Ballard Hub Site 1

1740 NW
Market St.

Early Design Guidance 2
SDCl Number: 3032775-EG
09-23-2019

EDG 1- What We Heard

Site 1: Market Street Level - Plan

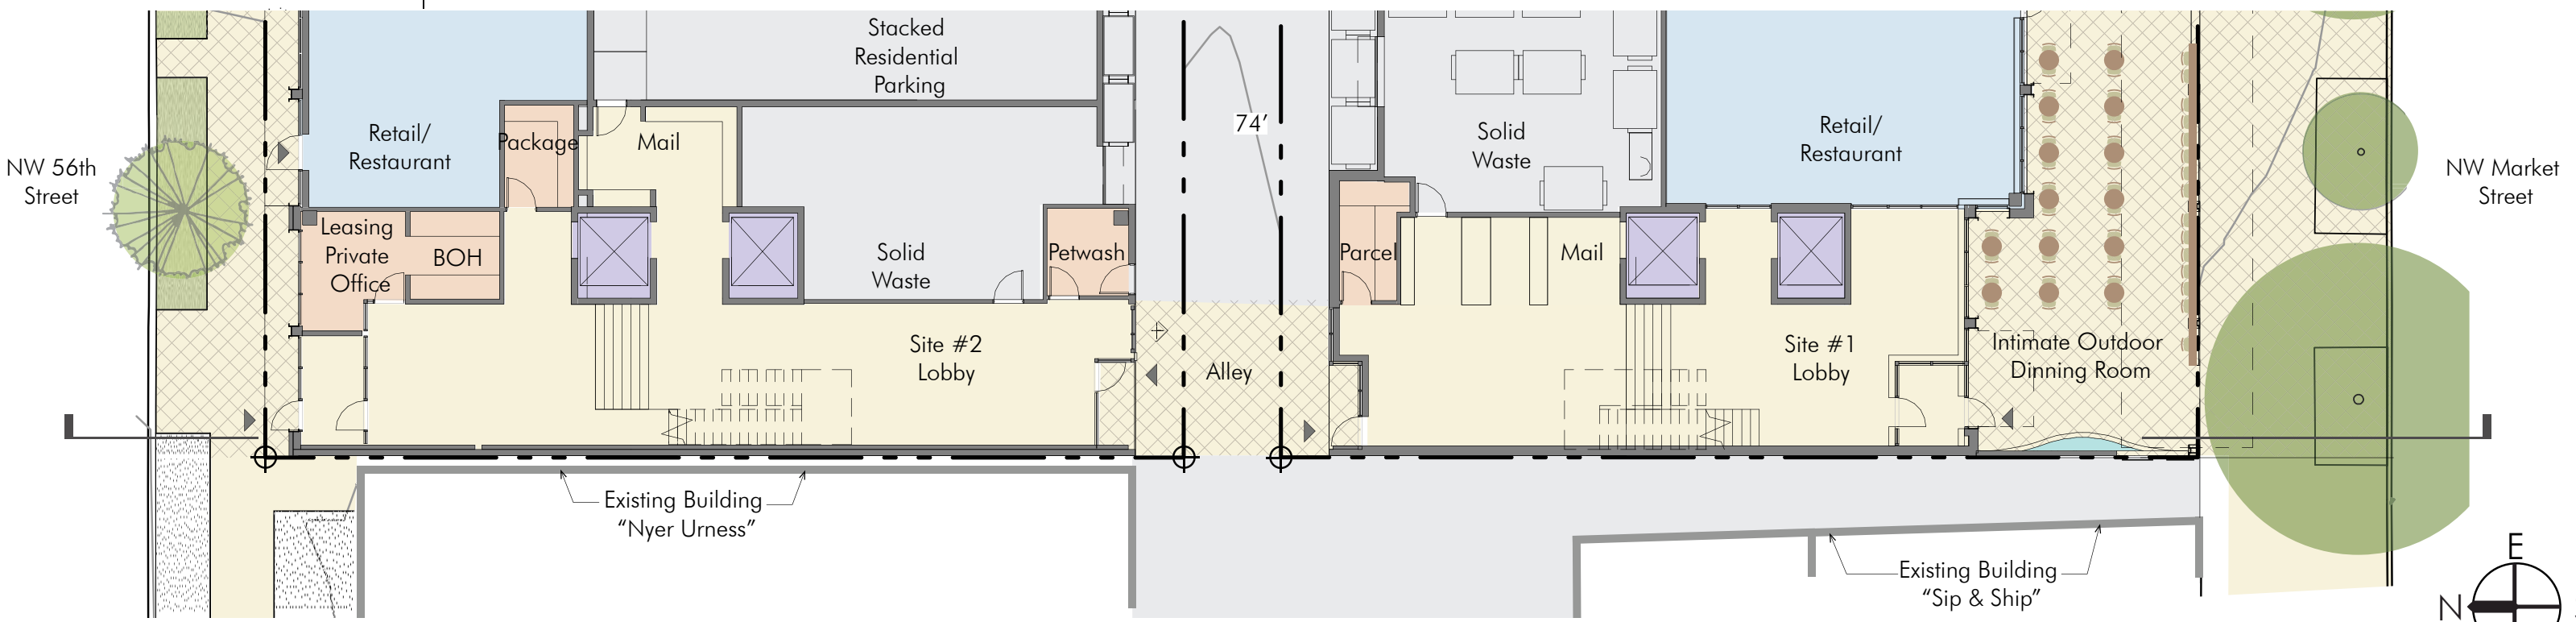
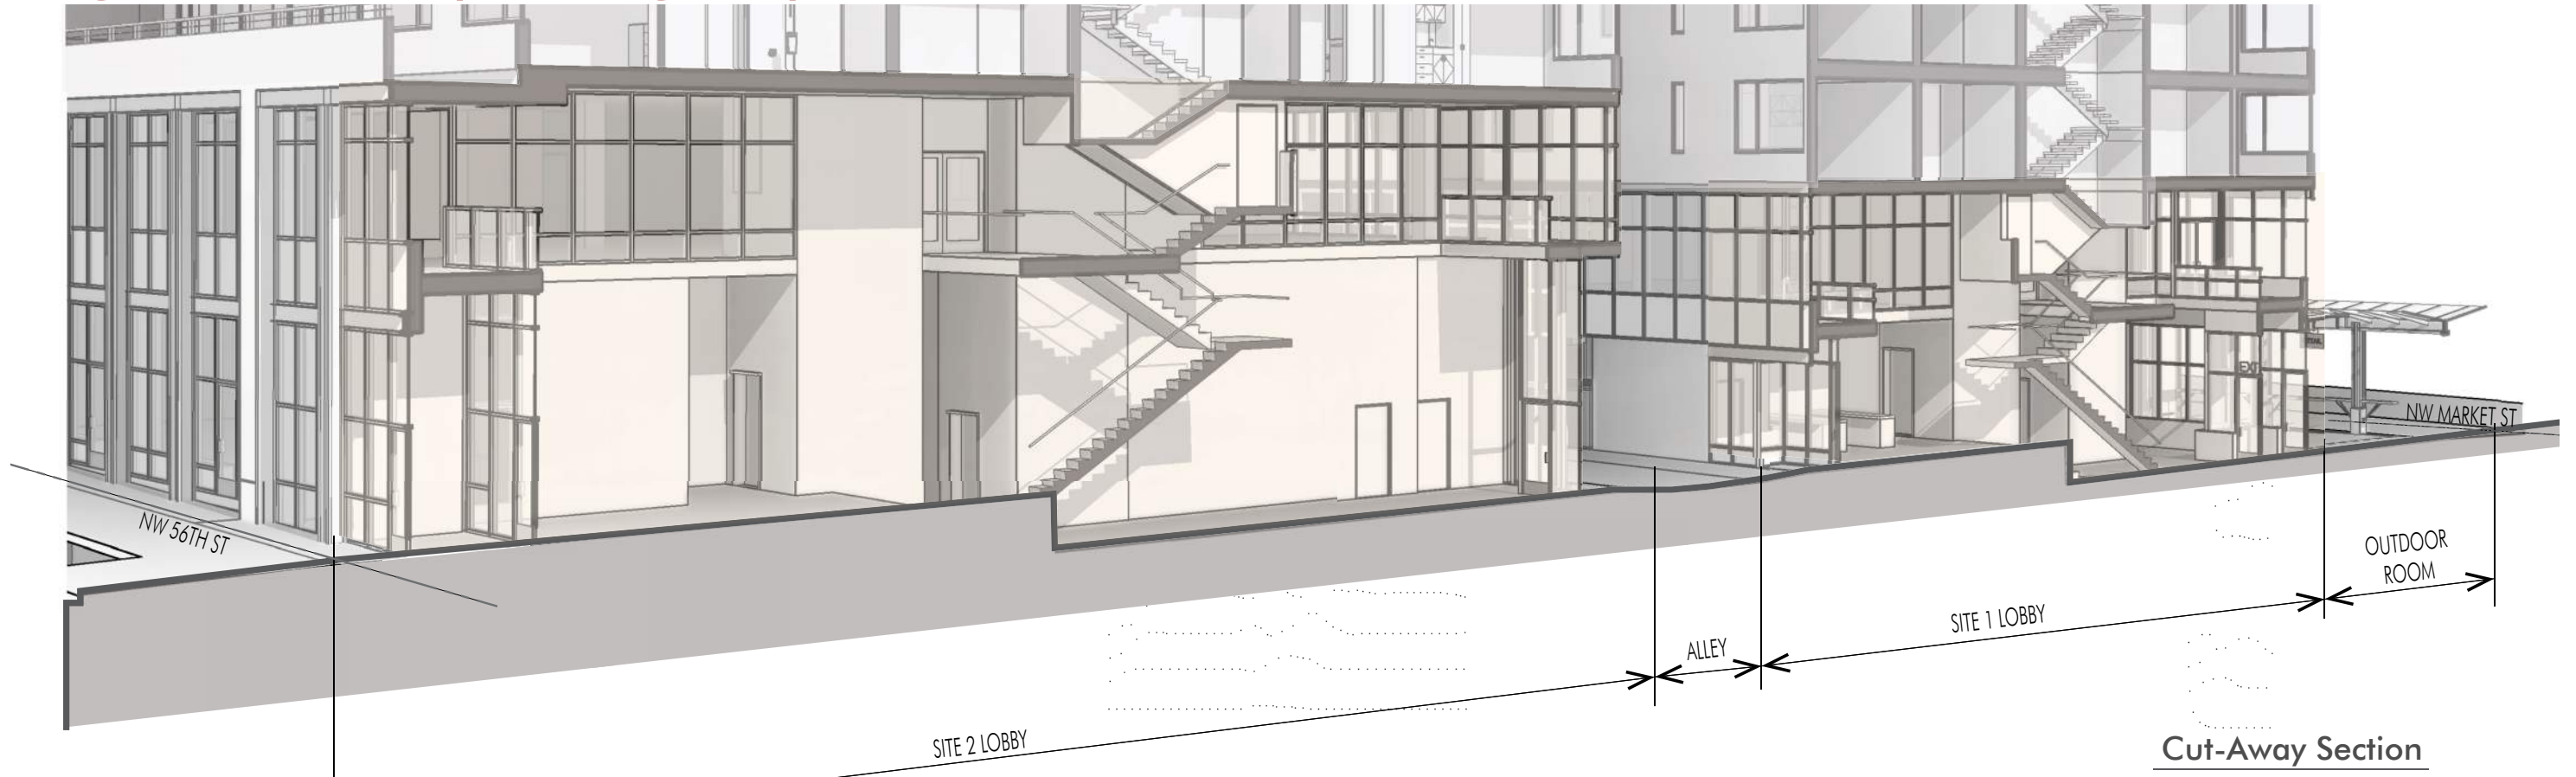
- a. Site 1: The Board appreciated the precedent images for the street level plaza space proposed for Site 1. The Board noted the plaza should be a porous, inviting space and still provide a sense of protection from the adjacent street and sidewalk. The Board requested the applicant look at simplifying the plaza. The Board thought a simplified plaza setting would be more successful and integrate better with the street edge. The Board also noted the proposed bicycle parking at the plaza/sidewalk edge creates an undesirable private plaza space that the Board did not support. (PL1.A, PL3.A, PL4.B)

- b. Site 1: The Board requested the applicant study how circulation would work in the plaza, with the Board noting that the plaza needs to be designed to be an active space. This may necessitate the plaza space being reduced in size along the street edge with Board members recommending the plaza not be overwrought with circulation. (DC3.B)

- c. The Board strongly supported the 25-foot wide building modulation at the street level. Based on this modulation, the Board requested the applicant look at creating a strong street edge and reducing the size of the proposed plaza. The Board recommended the applicant explore introducing a simplified two story building presence at the street edge that relates to the building massing and building design. (PL3.C, CS2.C, CS3.B)

- d. Site 1: The Board had concerns with the proposed butterfly canopy along the street edge of the plaza on Site 1. The Board noted that materials for the canopy should be in keeping with the Ballard design guidelines and suggested the use of steel or masonry, which relates to the industrial past of the area. The Board also suggested the proposed butterfly design may not be the most appropriate at this location and the applicant should consider an alternative canopy design. (PL2.C, DC4.A)

Function and circulation: This area is intended as very active off-sidewalk outside dining in support of street level restaurants. Circulation allows direct access to the lobby for office and residential uses as well as to street level retail, leaving the central portion free and flexible.

As requested, the narrow east half of this space has been eliminated and the street front retail brought to the property line to simplify the space.

The water harvest canopy is intended to be steel and glass and the butterfly shape lends itself to equally providing rain protection to the sidewalk and stand-up dining and one central gutter. Other shapes have been studied, but none meets both goals as well.

The East Facade

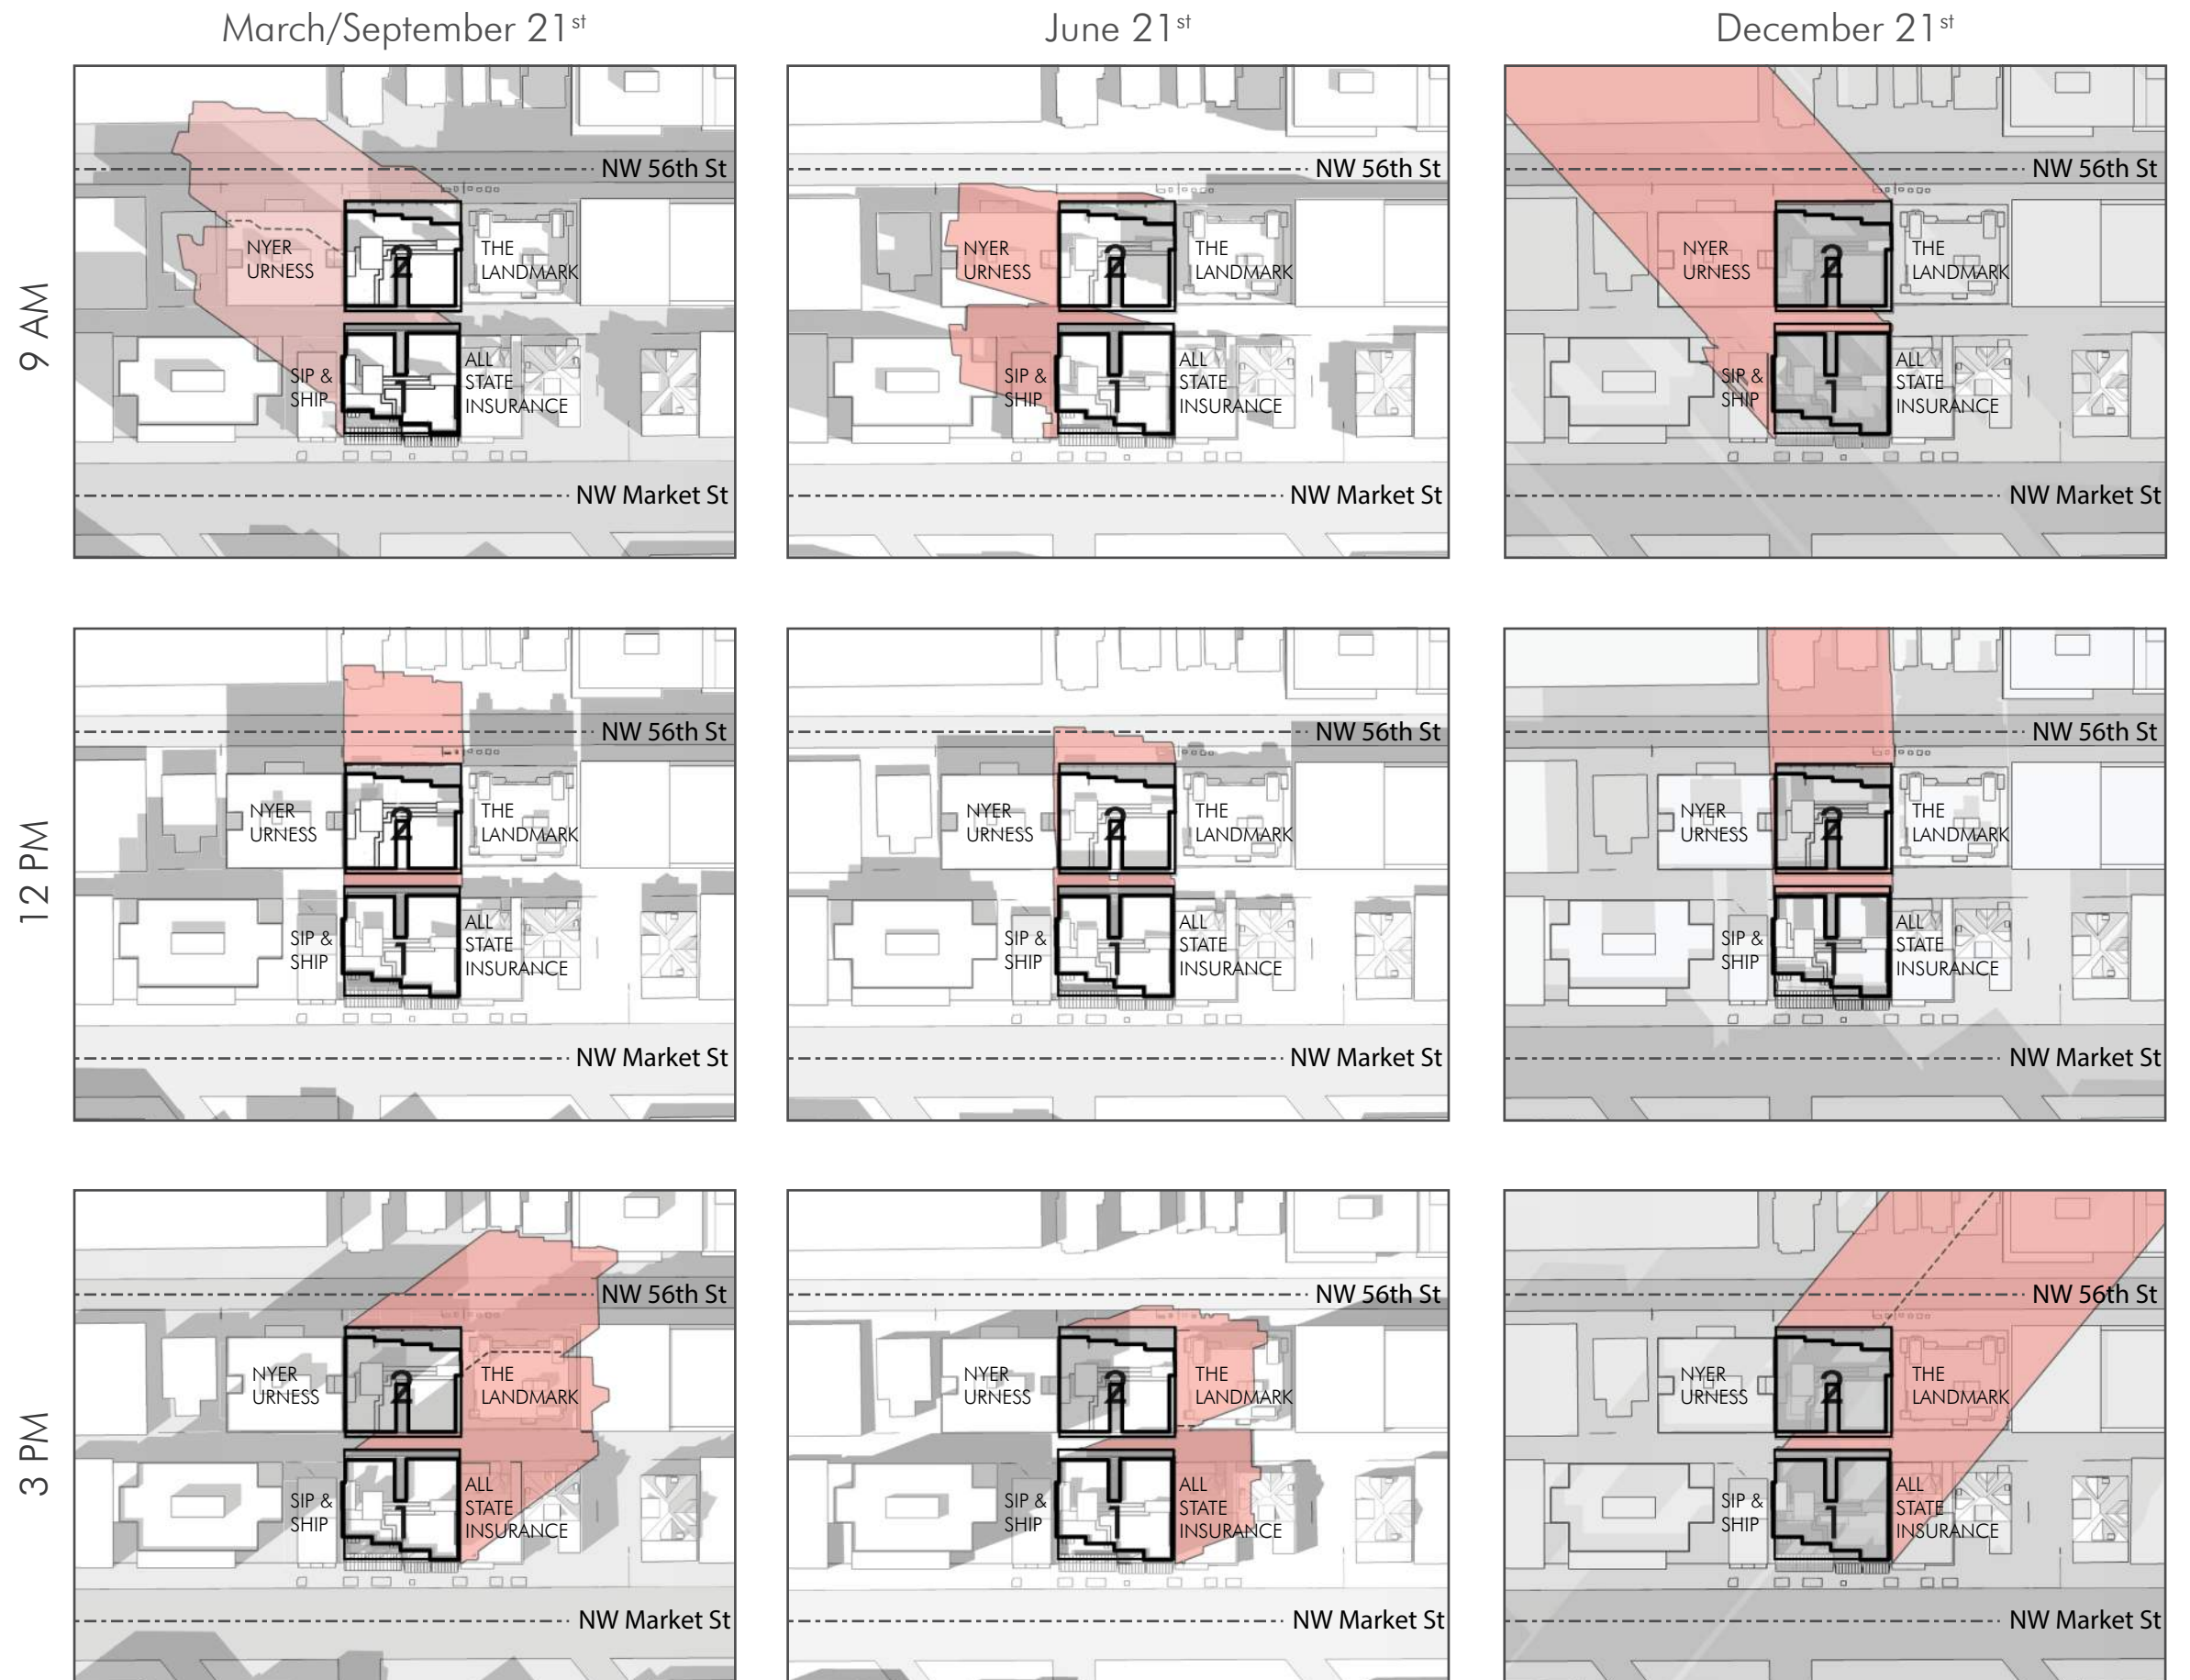
- a. Site 1: The Board appreciated the applicant's east façade design of Site 1 which incorporated a set back at the southeast corner of the building. This will enable the introduction of windows along a portion of the east façade to break up the wall and add interest to an otherwise blank wall condition. The Board requested more detail on this façade at the second EDG meeting. (DC2.B)

- b. Site 2: Responding to public comments provided at the meeting, the Board recommended the applicant provide special attention to details on the east facing wall on Site 2. The Board requested the applicant provide details on how the blank wall would be minimized based on the walls close proximity to the landmark structure to the immediate east. The Board requested the applicant apply a similar setback and fenestration on this façade as the proposed east façade on Site 1. Due to the presence of the landmark building next door, the Board requested the applicant also include a privacy study on this façade to the adjacent windows and balconies. (DC2.B, CS2.B)

The east façade of Site #1 has been set back between 5 and 3 feet along the full length of the shared property line, allowing fenestration along the entire elevation and providing more access to afternoon sunlight to the neighbors to the Northeast.

75% of the East façade of Site #2 has been set back from the shared property line a minimum of 5 feet, and up to 100 feet. The northeastern "sawtooth" has been pulled back to align with the Landmark Apartments northwestern balcony, maximizing its down street views. Where the façade is built to the eastern shared property line, it is strategically located to minimize the impact on the existing Landmark Apartments existing windows and balconies access to light and air, typically providing 15 feet of separation. Where possible, proposed windows of been misaligned with the existing landmarks, while providing fenestration and visual interest to the proposed Eastern façade where visible from Market Street

Across Site #1 & Site #2 80% of the façade has been set back from the shared Eastern Property line, maximizing allowed fenestration.

Additional modulation and property line setbacks presented in EDG #2 have reduced the amount of blank walls shown in EDG # 1 by 40% for Site #1 and 71% for Site #2

Blank Facade
 EDG #1 = 75' 11-1/4" Linear Feet
 EDG #2 = 21'-10" Linear Feet
 = 71% Less Blank Wall

Blank Facade
 EDG #1 = 87' 5" Linear Feet
 EDG #2 = 52'-9" Linear Feet
 = 40% Less Blank Wall
